**MEC** Mangum  
Engineering  
Consultants

24 June 1991

Ref: Proposed Diversion Ditch (D-7D) Modification, Co-Op Mining Company, Bear Canyon Mine, ACT/015/025, Emery County, Utah

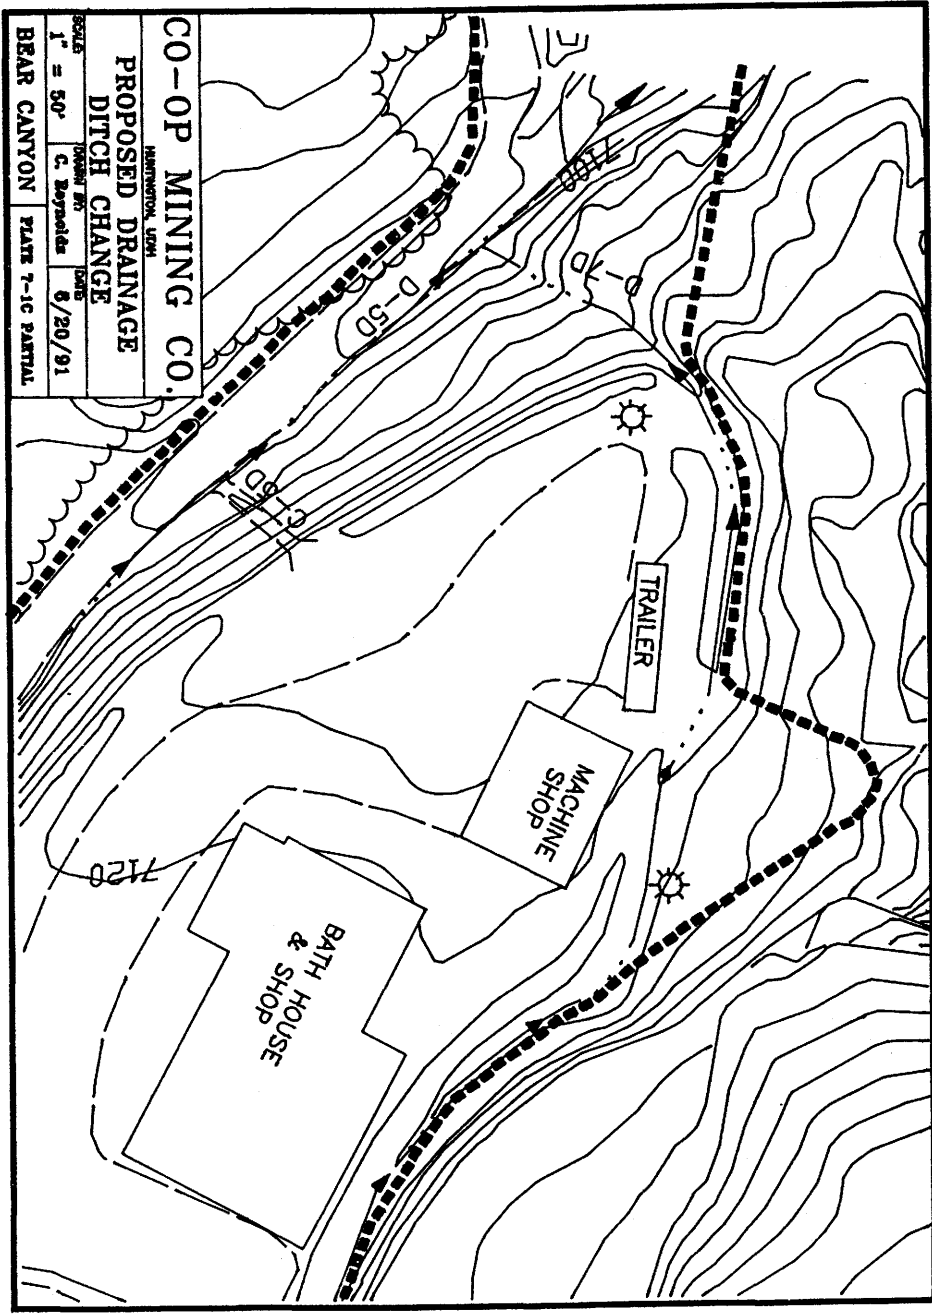
During a recent on-site visit it was observed that during the enlargement of Sediment Pond A, the flow path of diversion ditch D-7D was altered. Attached is a copy of a partial plan of Plate 7-1C, showing the changes made during placement of the removed fill material. The Ditch has been rip-rapped using existing calculations and profile Plate 7-1C. All of the changes were made within the Disturbed Area Boundaries.

Because of this change it was decided to remove the strip between the shop pad and the D-5D Sed pond drainage road from the areas defined on Plate 8-5 as "non-reclamation areas within the disturbed boundary". This area covers 0.17 acres. Accordingly pages 3-39 and 8-21 have been modified and are attached for your review. Because of the excess built into the bonding calculations no additional plan changes were required. Upon approval the effected plates will be modified and four copies submitted to the Division. Plates 2-4b, 2-4C, 7-1B, 7-1C, 8-5B and 8-5C will be updated as indicated.
